Docket Number:	14-AAER-02
Project Title:	Computer, Computer Monitors, and Electronic Displays
TN #:	204798
Document Title:	ITI/TechNet Comments on CEC Staff Report for Draft Display Standards
Description:	N/A
Filer:	Patty Paul
Organization:	Information Technology Industry Council (ITI/TechNet)/Chris Hankin
Submitter Role:	Public
Submission Date:	6/1/2015 9:36:39 AM
Docketed Date:	6/1/2015

CEC Draft Display Standards (Docket #14-AAER-2)

ITI/TechNet Comments on CEC Staff Report -- Displays

On Mode Compliance Assessment Summary

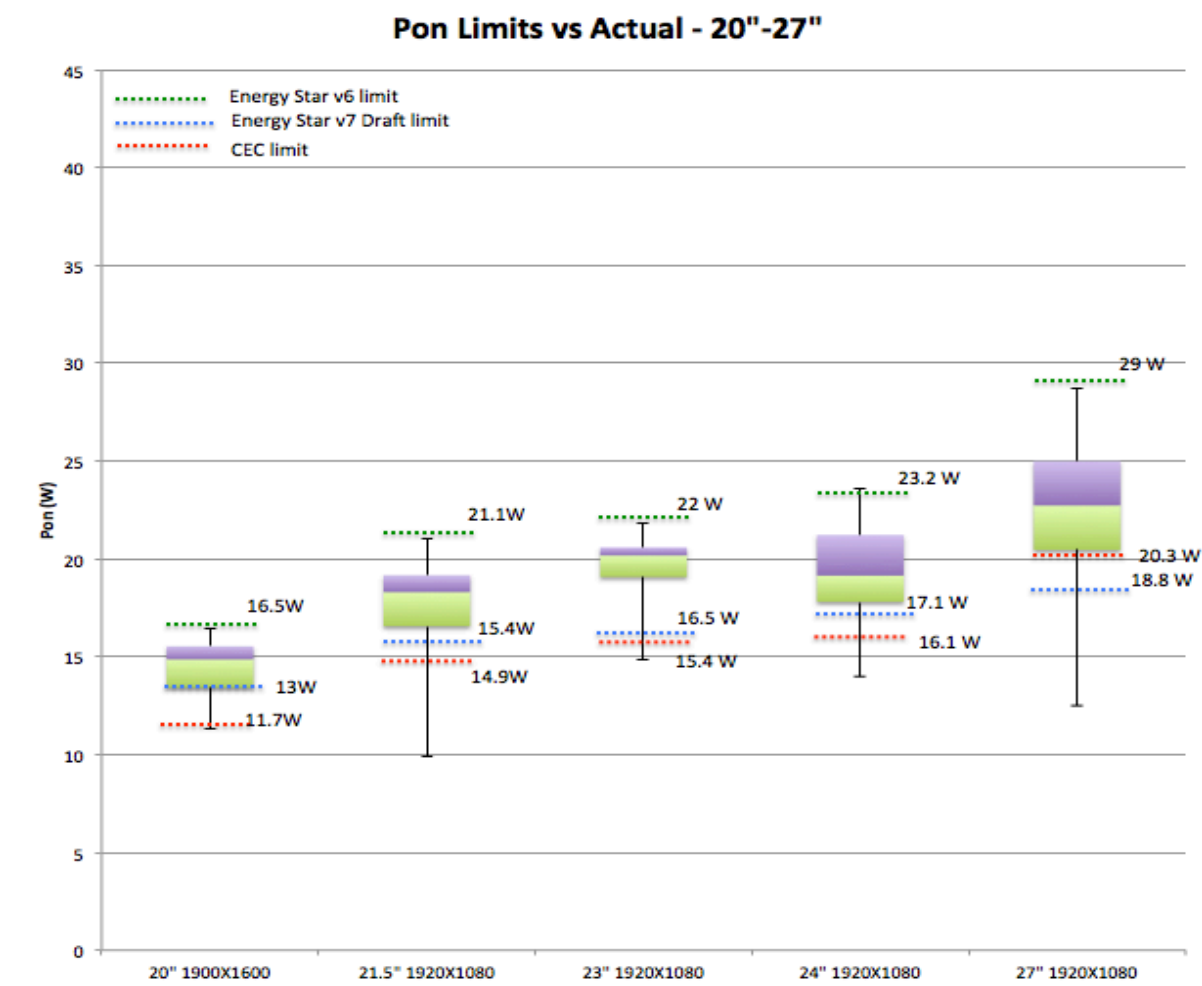
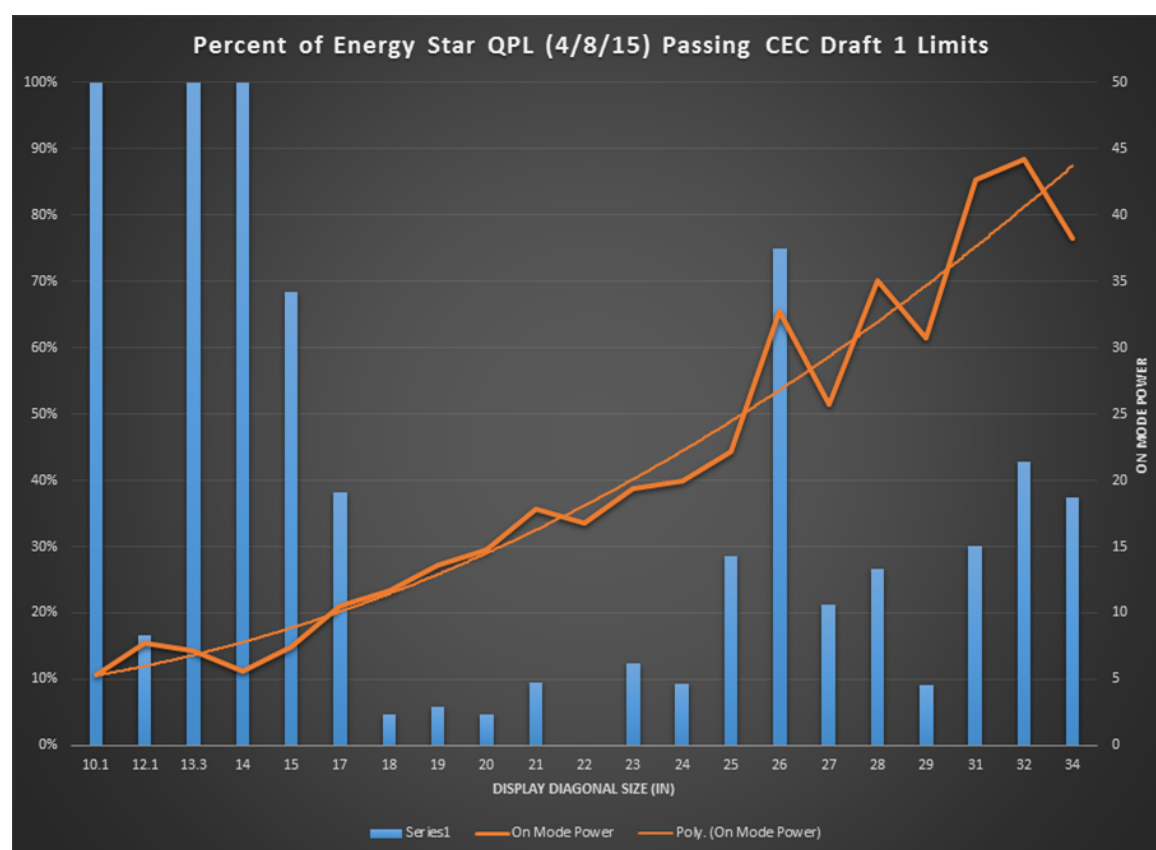
- 2.5 CEC's proposed Computer Display On Mode energy efficiency regulatory limits (with the sign error in formula corrected) impacts a minimum of 90% of the displays on the market (all sizes included – ENERGY STAR and non-ENERGY STAR qualified models). A manufacturer of professional displays concluded that 100% of their products would not meet the proposed regulations. CEC confirmed that there was an error in the On mode formula for display in the 23" $\leq D < 25$ " and 25" $\leq D < 61$ " size ranges, that should show a minus sign.

Impacts of CEC's proposed On Mode limits are not proportional across range of display sizes. The percentages of displays that do not comply with CEC's proposed On Mode limits is shown in the On Mode Compliance Assessment Summary Table below. The On Mode limits proposed for Computer Displays is unrealistic from both a technology and cost perspective with the current state of display technology and design. CEC should evaluate all of the Computer and Signage Displays on the market when determining what are appropriate and cost effective limits for Computer and Signage Display On Mode limits.

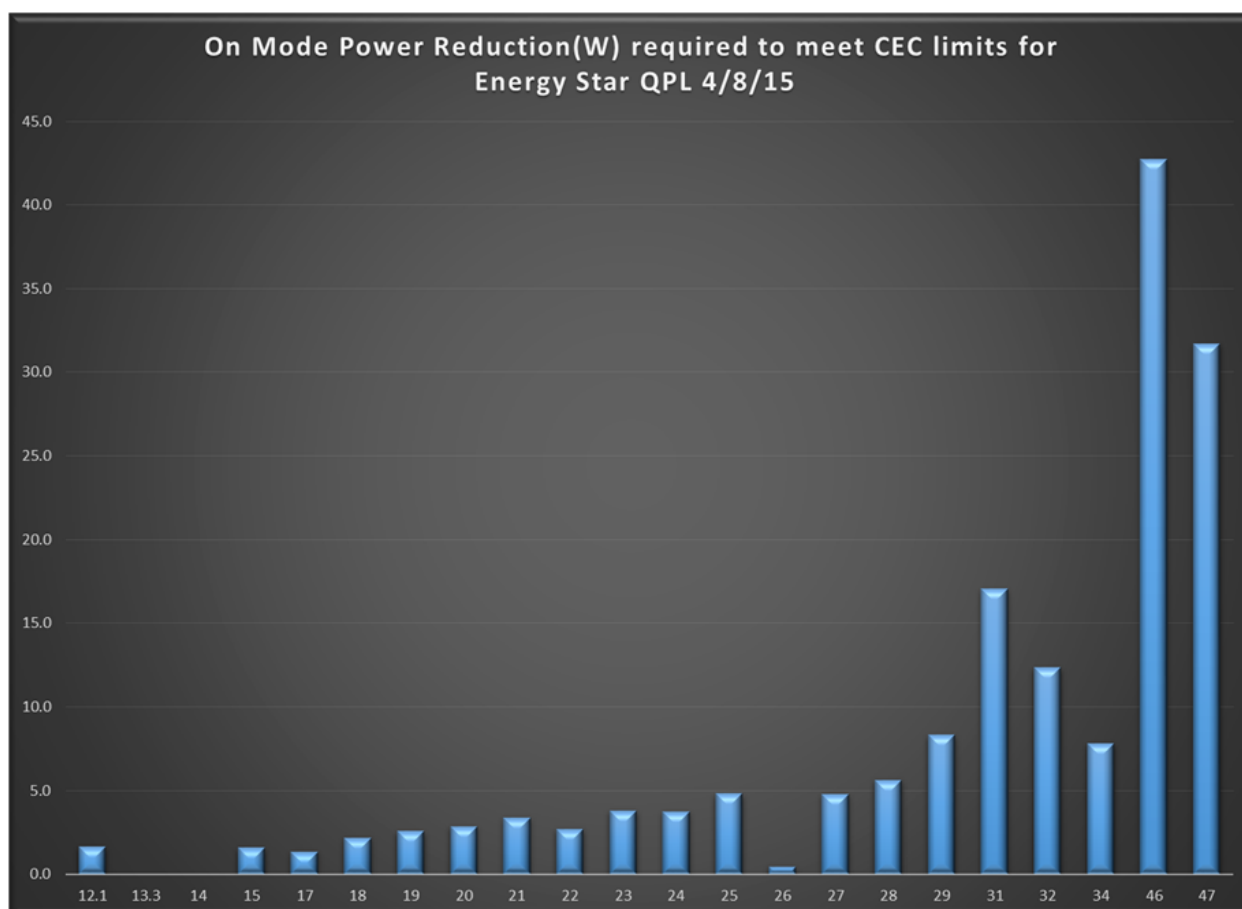
In CEC's Staff Report they note that manufacturers do not need to improve the power consumption of displays substantially to comply with the On Mode limits they proposed. CEC states in the Staff Report that *'...only about 14% of current models meet the staff's proposed standards. However, monitors would only need to reduce their power consumption by 3 to 5 watts to comply'*.

Power Consumption data that manufacturers have indicates that the On mode power consumption reduction required to meet the limits CEC proposed, are substantially greater as shown in the table below. This graph shows the average on mode power reduction required to bring the failing displays in the current Energy Star Display data base into compliance with the CEC proposal. Depending on the size, the On mode power consumption reduction required to meet the On mode limits CEC proposed ranges from 5 to ~ 45 Watts for displays 25 in. diagonal and above.
